## Product Change Notice (PCN)

**PCN Number:** PCN-0456246R-01

Product(s) Affected: *SJ1-2503A*

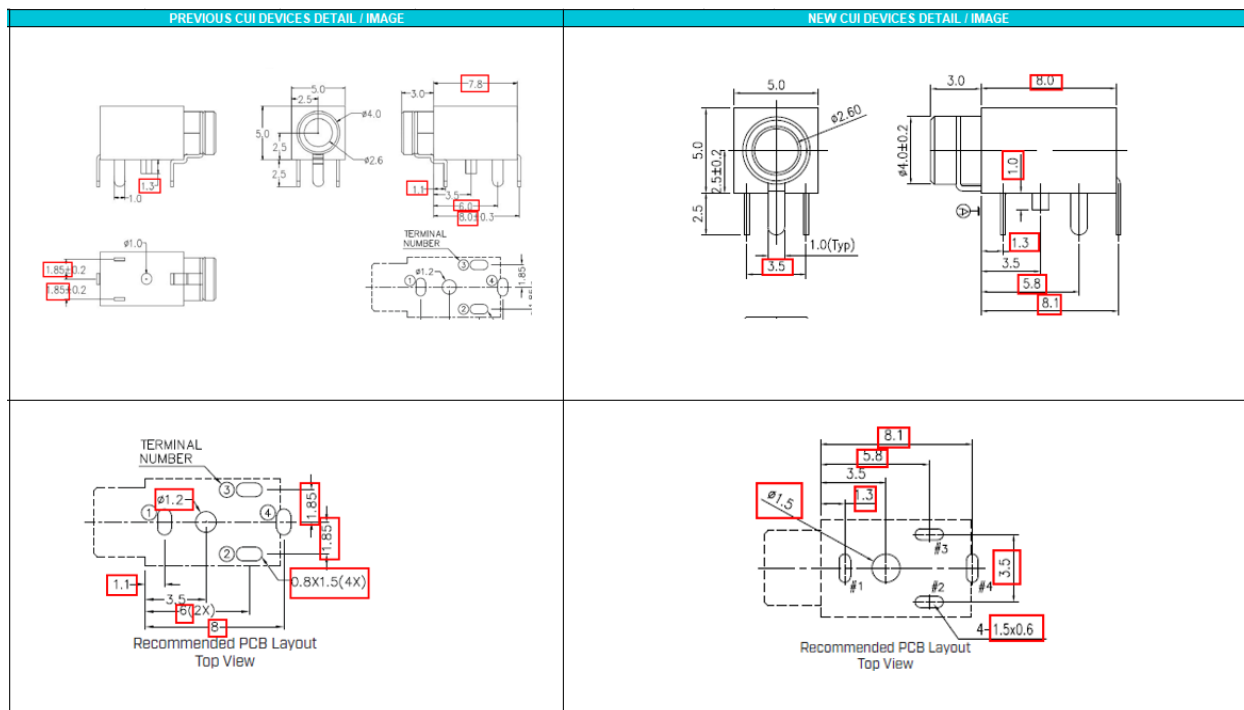
Description of Change: *New Factory Location. Product re-engineered for improved manufacturability and production yield. See image below for reference and check CUI Devices website for updated drawing. Cosmetic differences may be visible and not affect the form fit and function of the product.*

PREVIOUS CUI DEVICES DETAIL / IMAGE			NEW CUI DEVICES DETAIL / IMAGE		
DESCRIPTION	MATERIAL	PLATING/COLOR	DESCRIPTION	MATERIAL	PLATING/COLOR
terminal 1	brass	silver	terminal 1	phosphor bronze t=0.30	tin over nickel
terminal 2	copper alloy	silver	terminal 2	phosphor bronze t=0.30	tin over nickel
terminal 3	copper alloy	silver	terminal 3	phosphor bronze t=0.30	tin over nickel
terminal 4	copper alloy	silver	terminal 4	brass t=0.30	tin over nickel
bushing	brass	nickel	bushing	copper alloy	nickel
housing	PBT (UL94V-0)	black	housing	PAB (UL94V-0)	black
